**University Avenue
Improvements &
Artwalk 2
Enhancement Project
City of Rochester**

**LANDSCAPE
DETAILS
(ANDERSON ARTIST
BUILDINGS)**

University Avenue Improvements and ARTWalk 2 Enhancements Project

Anderson Alley Artist Building Plaza Coordination Meeting

ART DISPLAY PANEL DETAIL
SCALE: 3/8\"/>

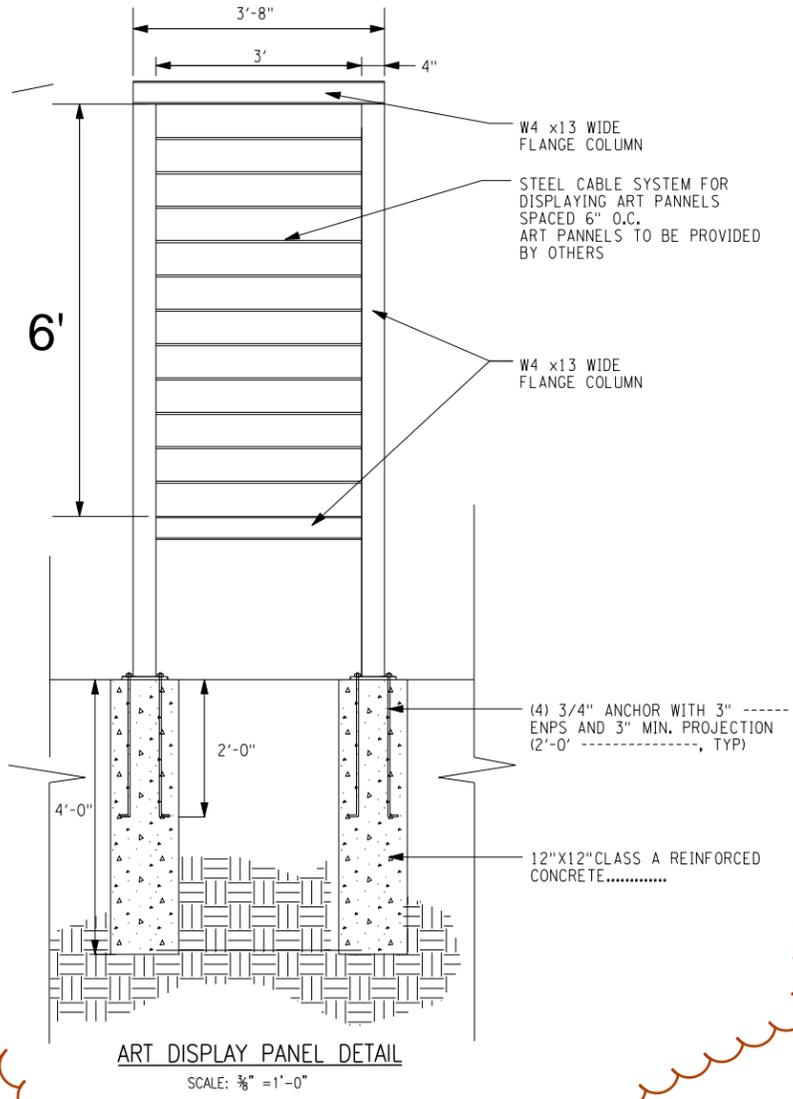
1. Sue distributed the latest concept sketches for the Art panels (attached) for discussion.
 - o The design proposed six panels for the Art exhibit, three located on each side of the sidewalk leading to the front entry of the building.

- o The panels are three feet wide and eight feet tall with the lowest crossbar at two feet above grade.
 - o The panel frame is a steel frame with holes drilled to support a cable system for hanging the Art.

- o The panels are arranged to face the street with two angled to face pedestrian and vehicular traffic traveling in the north-south direction.
 - o In-ground lighting will be provided to all of the panels, power supply needs to be identified.

2. The following comments were provided on the design of the sign panels.
 - o Eric requested that the holes drilled into the frame should be spaced every six inches for wire and attachment.

- o Eric would prefer the dimension inside the frame to be three feet wide and six feet tall.
 - o Eric commented that the panels will have an anti-graffiti laminate.

- Clip, both with a 3/8" opening for the wire to pass through. These attachment components are semi-disposable. (available on drytac.com)
 - Sue will provide a cut sheet of the wire proposed for the frame (Jakob brand recommended).

- Power for lighting the panels may be available on the former Fabrics and Finding Sign, the timer for the sign is located in BookSmart Studio.
 - Panels need to accommodate artist recognition; this will be a place for the current exhibit artist to be recognized and has to be easy to change.

- Panels should include a permanent recognition panel for the Exhibit Sponsor (BookSmart Studio) and Curatorial Responsibilities (TBD).
 - BookSmart Studio will be printing all of the Art panels for duration of at least eight years.

3. The following comments were provided on the layout of the Art panels.
- Eric suggested facing the entire six panels towards N Goodman Street and adding one panel at the corner of Anderson Avenue to face the opposite corner of the intersection.

- Keeping the panels symmetric is important.
4. Paul informed the group that we received City Council authorization for the easement. An agreement needs to be put together for the appraisal. The agreement will include maintenance, operations, and curatorial responsibilities associated with the proposed design.

1. Sue to provide Eric with the wire system being proposed.
2. Bergmann to revise the panel design and layout to meet the requests stated above and send updated sketch.
3. Bergmann to set up a meeting with the City, ARTWalk, Adam, and Eric for early January.
